Pre-bid Clarifications No. 3 Dated 23.01.2025 to Pre-bid queries on stipulations of Bid Document against NIB No. 457 Dated 25-10-2024 for "Package-I: Construction of Civil Works on Item Rate for Tato-I Hydro Electric Project, Arunachal Pradesh, comprising of Headworks & allied works, Head Race Channel, Head race Pipe, Intake, Headrace tunnel, Surge shaft, Pressure shaft, Valve house, Power house & allied works and Infrastructure works"

(This Pre-bid Clarifications shall supersede the corresponding stipulations of the Bid Document, wherever these are at variance.)

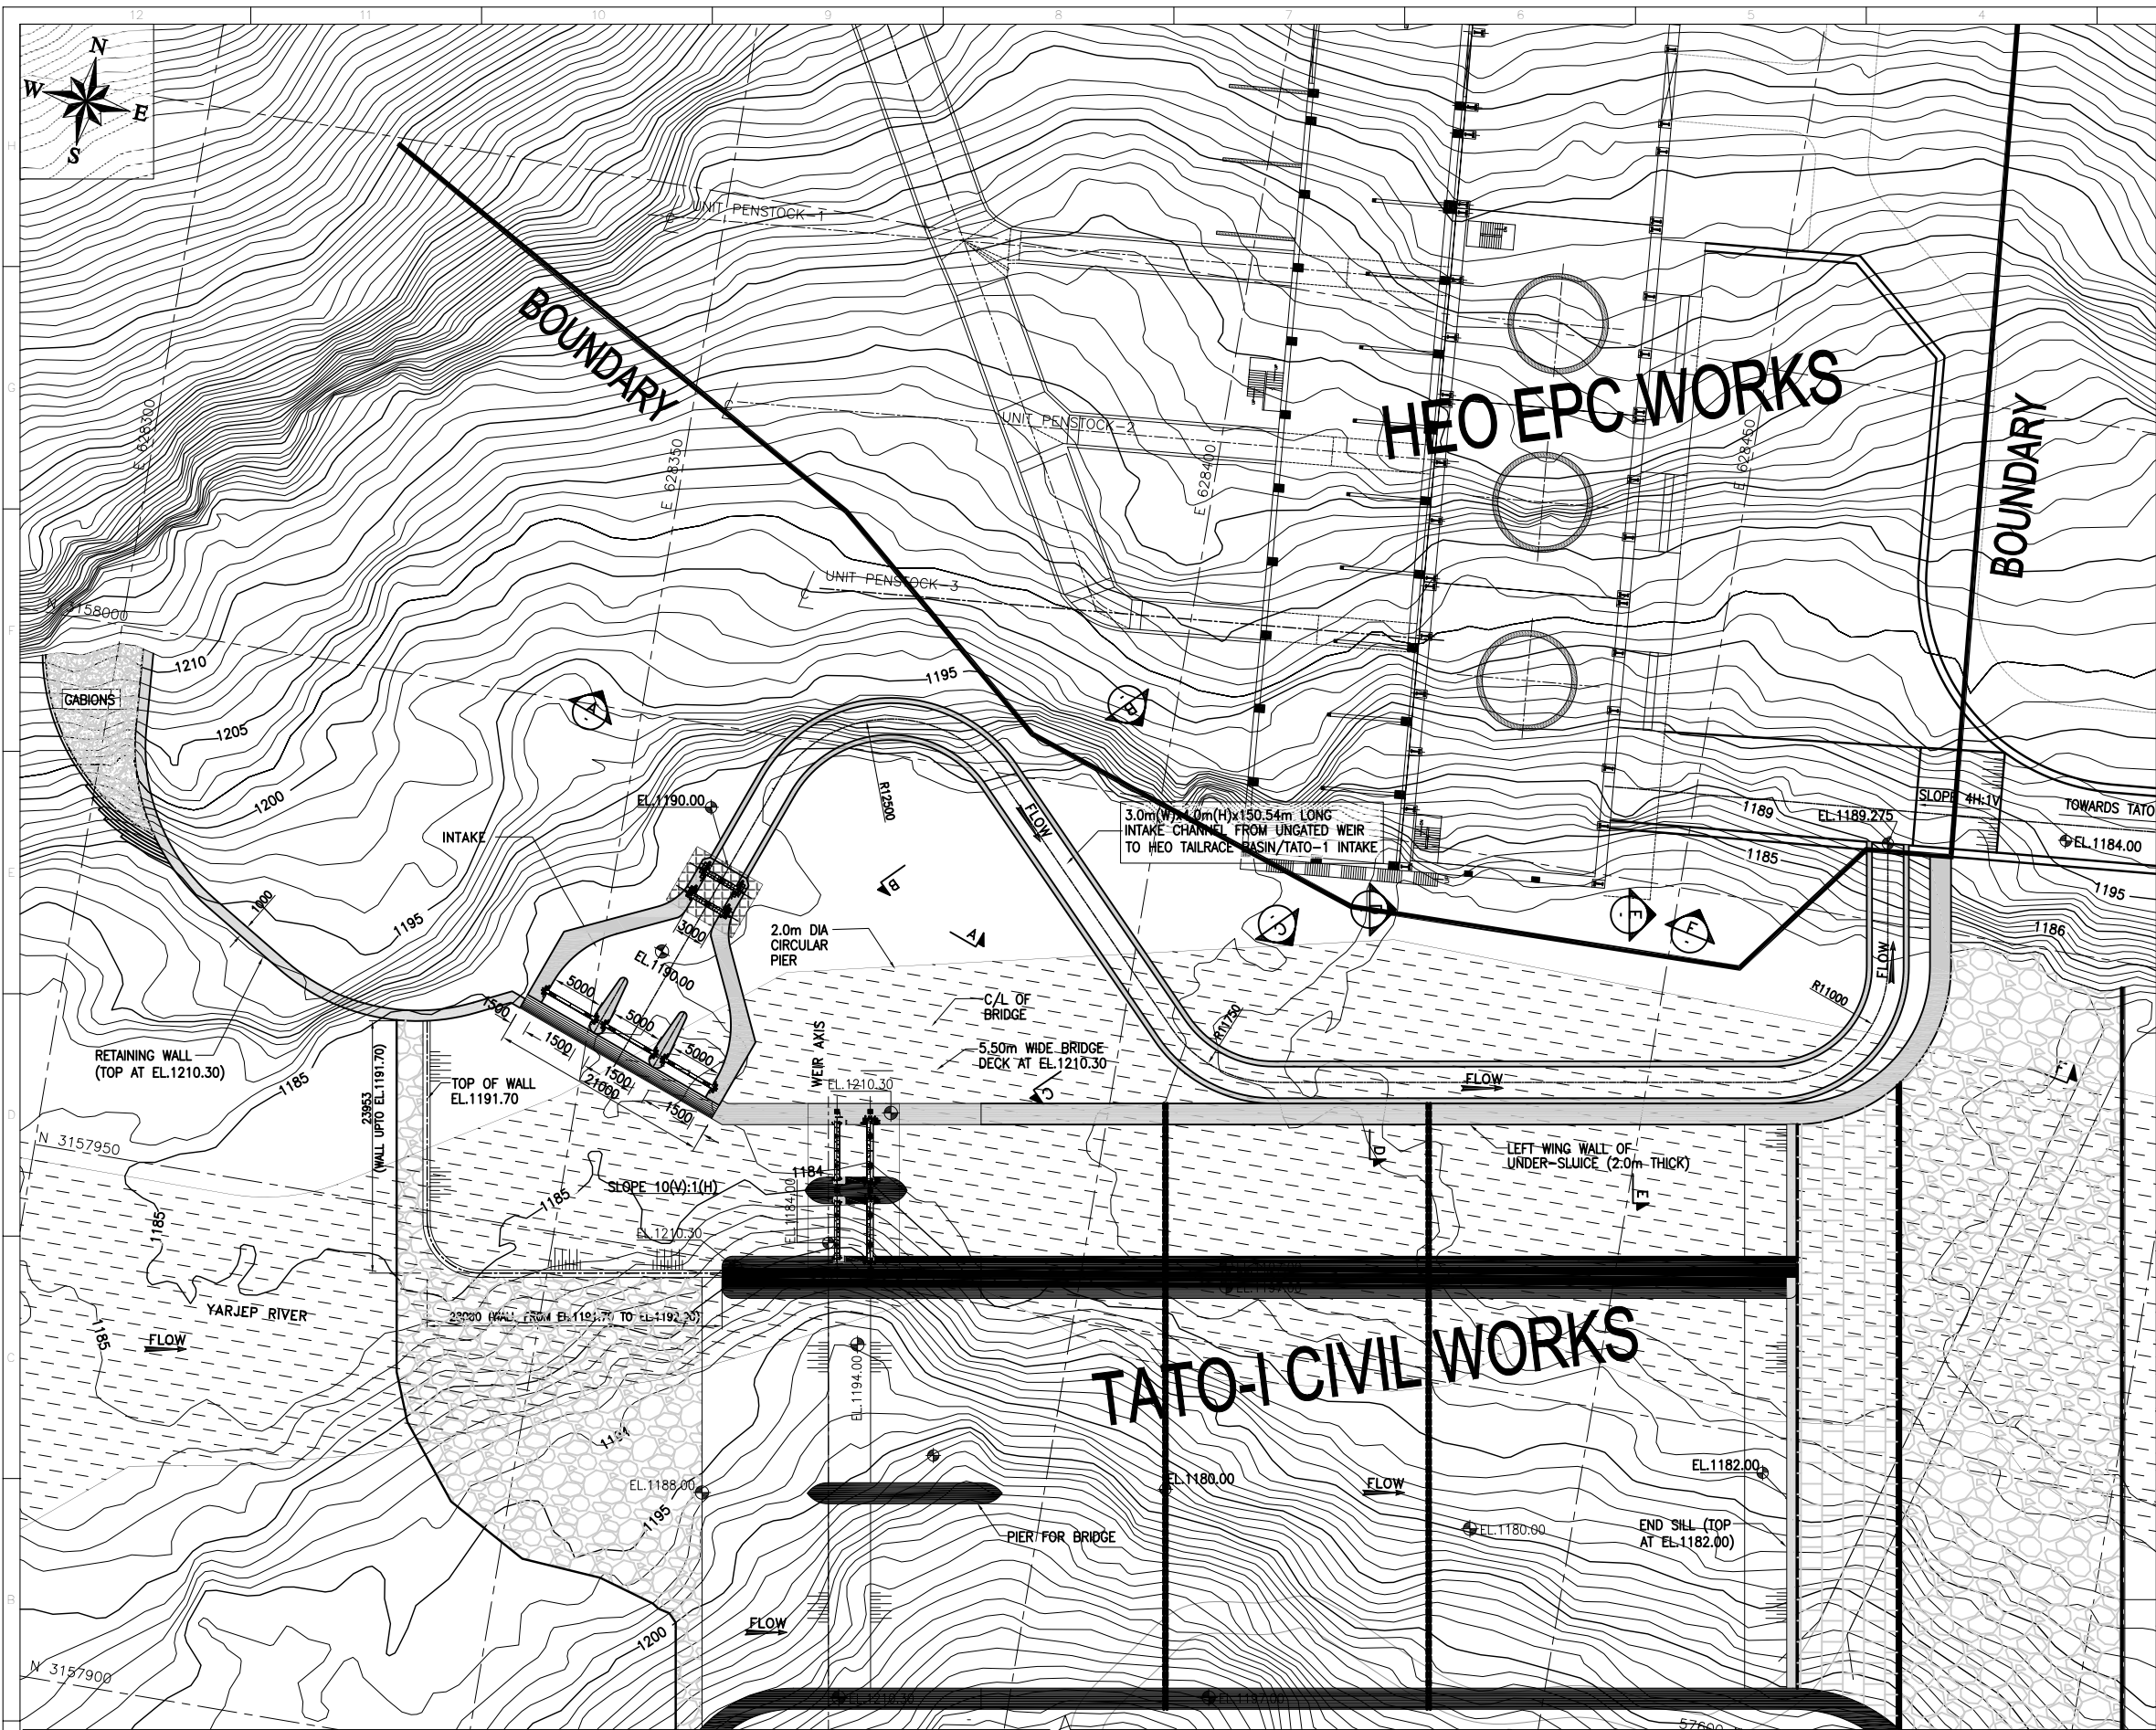
Sl. No.	Reference to Bid Document Clause	Provision of Bid document	Pre-Bid queries of Bidders	NEEPCO's Clarifications
4	Queries of Pre-Bid Meeting		Demarcation between the scope of Tato-I & Heo HE Project Works.	The boundary between the Tato-I Project and Heo Project is demarcated in the layout plan, enclosed herewith.
